Access Compliance Report

Public Rights-of-Way

Intersection ID: 2963	Main Street: MADISON_PARK_DR	Cross Street: WHITE_ASPEN_PL	Location:	N
ADA ID: 83457029EEF1	Ramp Type: BlendTrans1	Initial Pass/Fail: Pass	Overall Compliance: No	Severity Score: 0
Codes/Mitigation Info/Possible Solution		Field Measurements/Component Compliance

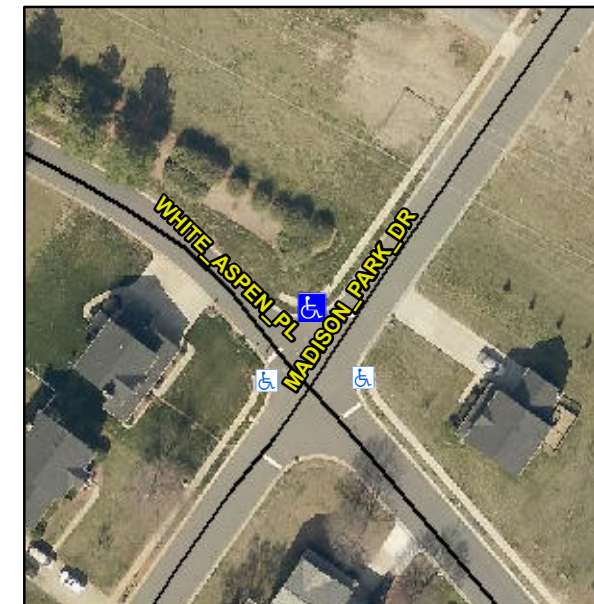
Not Found, R304.2.1, R304.2.2-Perp, R304.3.2-Para, R304.5.3, R305.2

Compliance	Description	Data	Compliance	Description	Data
N/A	Ramp Length (in)	48.0	Yes	BlendTrans Slope (%)	4.2
Yes	Ramp Width (in)	48.0	Yes	BlendTrans XSlope (%)	1.8
N/A	Flare Type LT	Sloped	N/A	Flare Type RT	Sloped
N/A	Flare Slope LT (%)	8.7	N/A	Flare Slope RT (%)	7.8
N/A	Flare Traversable LT?	No	N/A	Flare Traversable RT?	No
No	Landing Length (in)	46.0	Yes	DWS Provided?	Yes
Yes	Landing Width (in)	48.0	Yes	DWS Contrast?	Yes
No	Landing Slope (%)	3.9	Yes	DWS Length (in)	25.5
No	Landing X Slope (%)	3.9	Yes	DWS Full Width?	Yes
N/A	Landing Curb? (Y/N)	No	No	DWS Offset (in)	3.0
N/A	Shared Landing?	No			
Yes	Gutter Ponding?	No	Yes	Gutter Slope (%)	0.1
Yes	Gutter Lip Ht (in)	0.0	Yes	Gutter X Slope (%)	0.5
N/A	Painted X Walk1?	No	N/A	Painted X Walk2?	No
	X Walk 1 Direction	To SW		X Walk 2 Direction	To SE
	X Walk 1 Width (in)	N/A		X Walk 2 Width (in)	N/A
	X Walk 1 Slope (%)	1.3		X Walk 2 Slope (%)	2.2
	X Walk 1 X Slope (%)	1.1		X Walk 2 X Slope (%)	1.7

N/A	Ramp inside XWalk1?	N/A	N/A	Ramp inside XWalk2?	N/A
	Road Slope (%)	0.1		Clear Space?	Yes
	Road X Slope (%)	2.8	N/A	Clear Space to XWalk (in)	N/A
Yes	Any Obstructions?	No	Yes	Storm Grate/Utility Hazard?	No
	Obstruction Type			Storm Grate/Utility Type	
		N/A			N/A
			Yes	Surface Condition? (G/P)	Good
			No	Curb Slope (%)	8.6

Remove & Replace Curb Ramp With Two New Directional Ramps or Equivalent.
